U S NAVY RESPONSE TO THE U S EPA REGION I AND THE RHODE ISLAND  
DEPARTMENT OF ENVIRONMENTAL MANAGEMENT COMMENTS REGARDING THE  
DRAFT FEASIBILITY STUDY REPORT FOR SITE 7, TANK FARM 1, OPERABLE UNIT 13 (OU  
13) NS NEWPORT RI  
12/23/2014  
DEPARTMENT OF THE NAVY

**Navy Responses to Regulatory Agency Comments**  
**EPA Comments, October 28, 2014**  
**RIDEM Comments, November 17, 2014**

**Draft Feasibility Study Report for Site 7 – Tank Farm 1, OU 13**  
**NAVSTA Newport, RI**

**December 23, 2014**

FIGURE 9  
 SURFACE SOILS EXCEEDING PRGs  
 TRANSFORMER VAULT 2  
 TANK FARM 1 (SITE 7)  
 NAVSTA NEWPORT, RHODE ISLAND

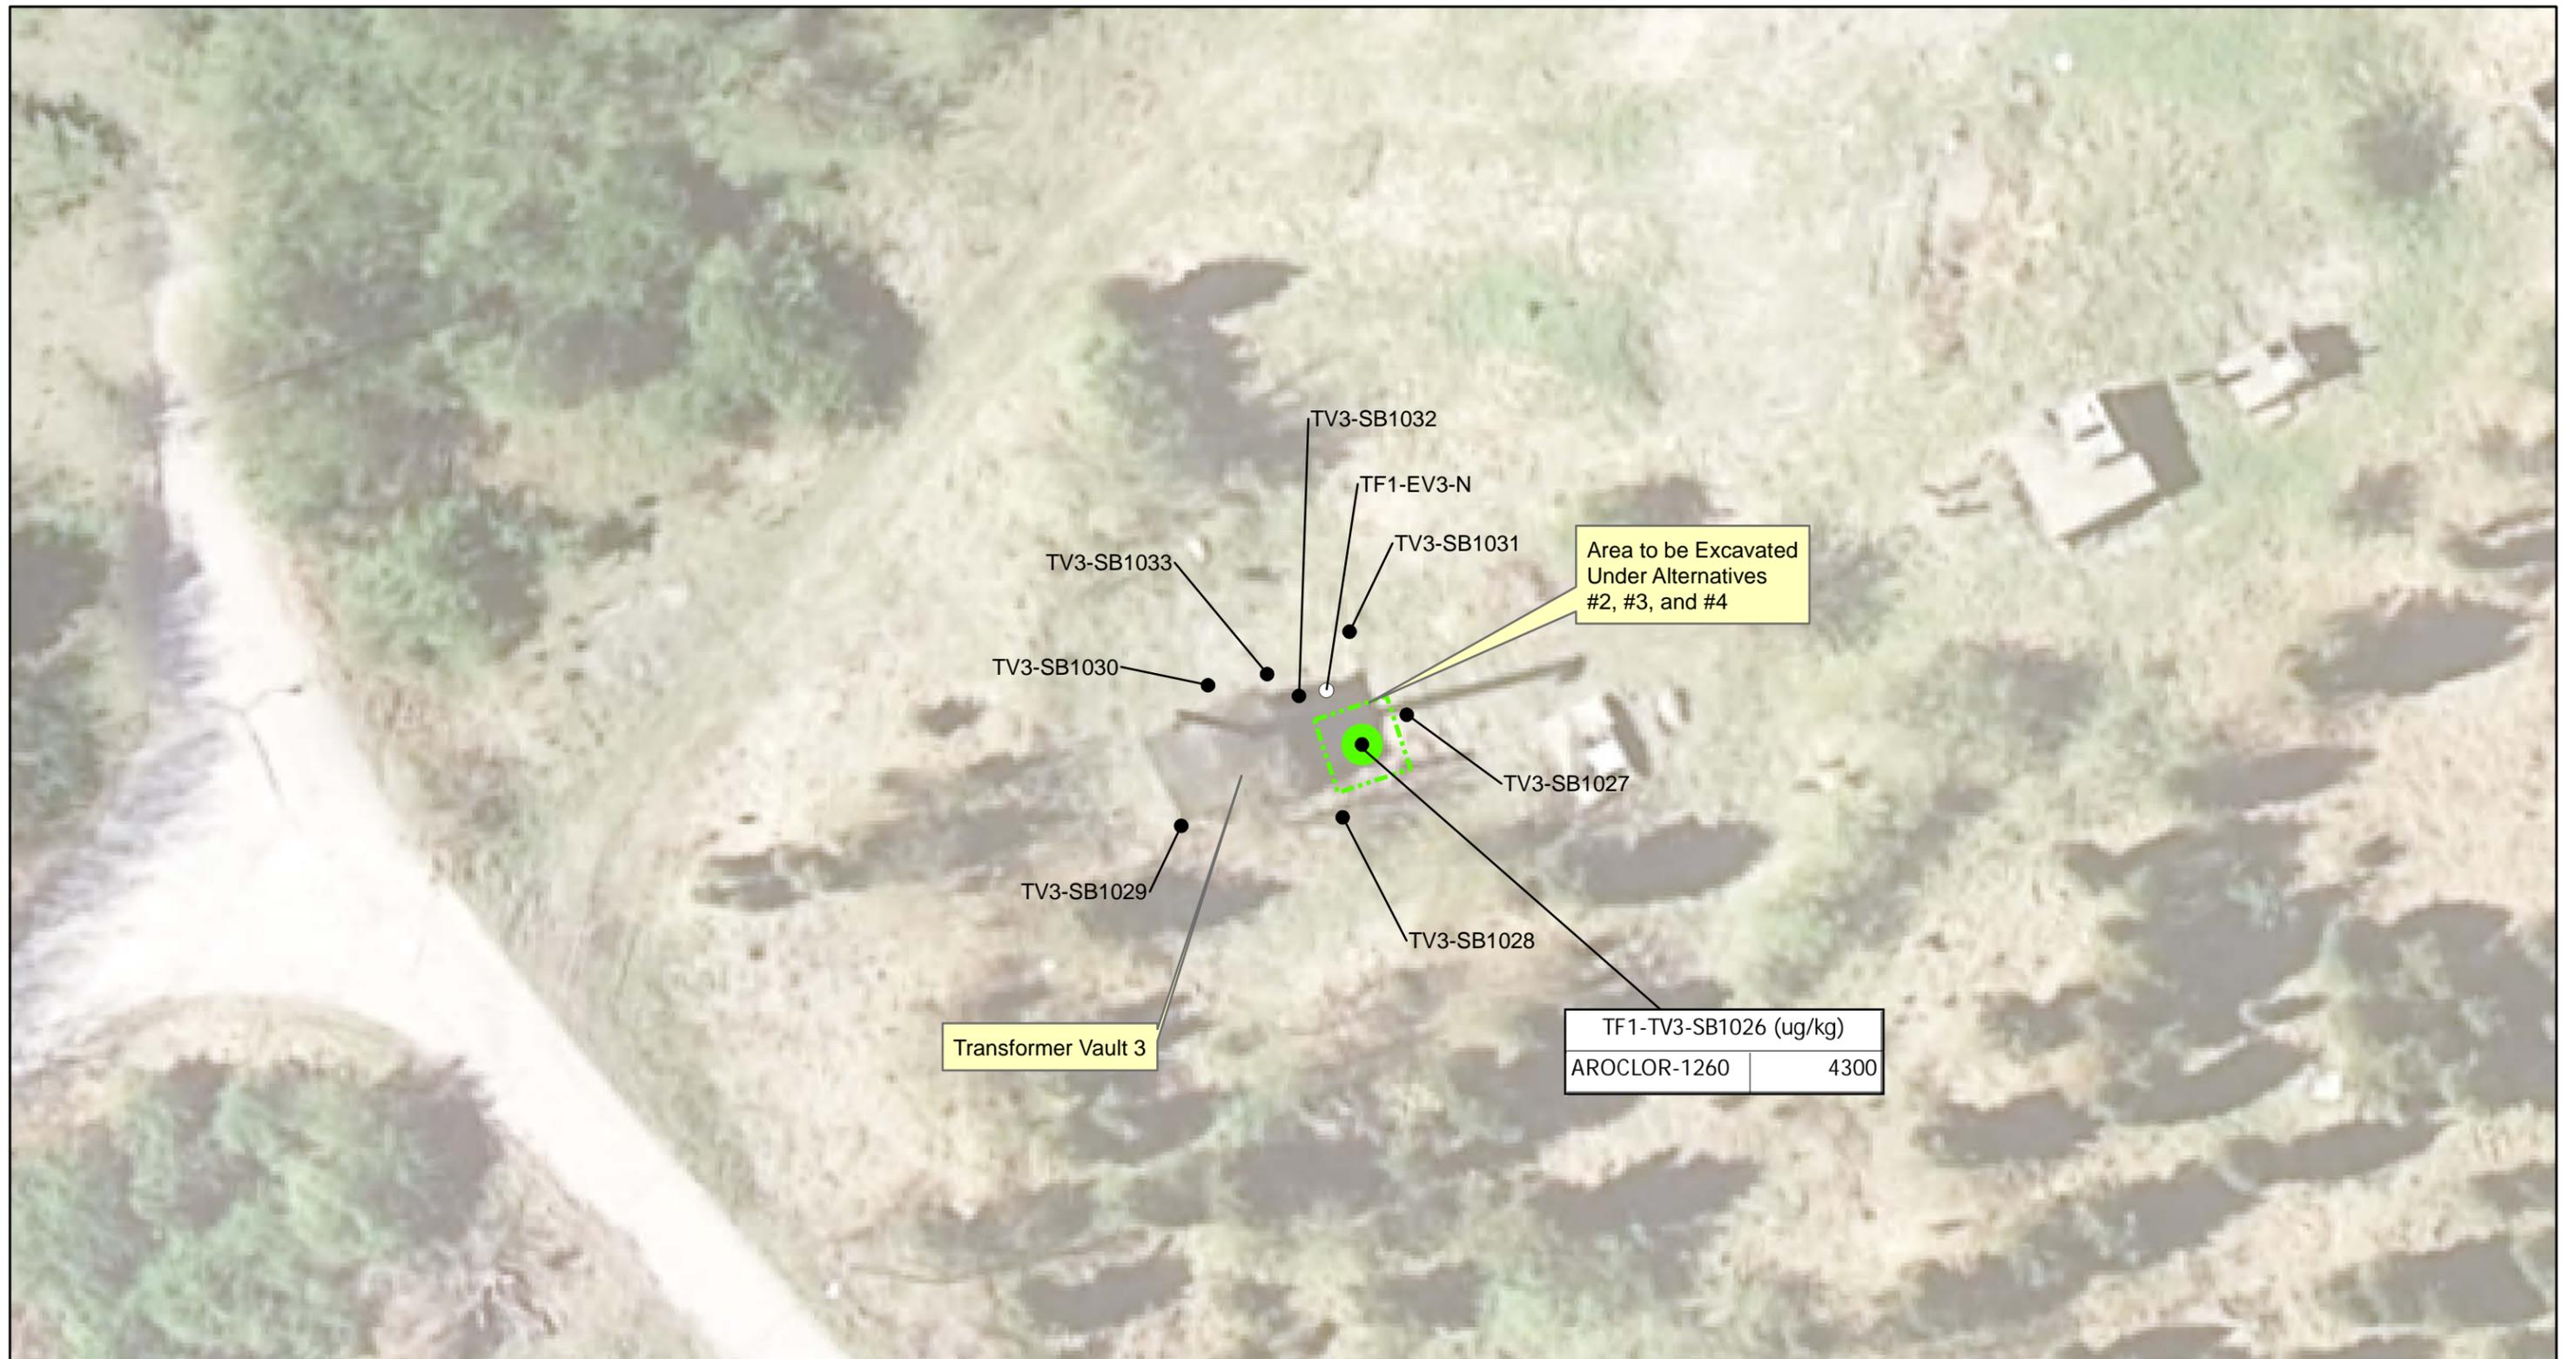
***EPA Specific Comment 98:*** Figure 9 - The sample locations in this figure differ from Figure 2-2 in the Draft Final Data Gaps Assessment Report from April 2014. Please correct the sample locations in Figure 9, all of which are erroneously offset.

**Response:** The sample location coordinates presented on Figure 9 are correct. The appearance of the offset is due to the angle at which the aerial photograph was captured. During the remedial design, the location of the samples in relationship to the EBP structure will be field verified.
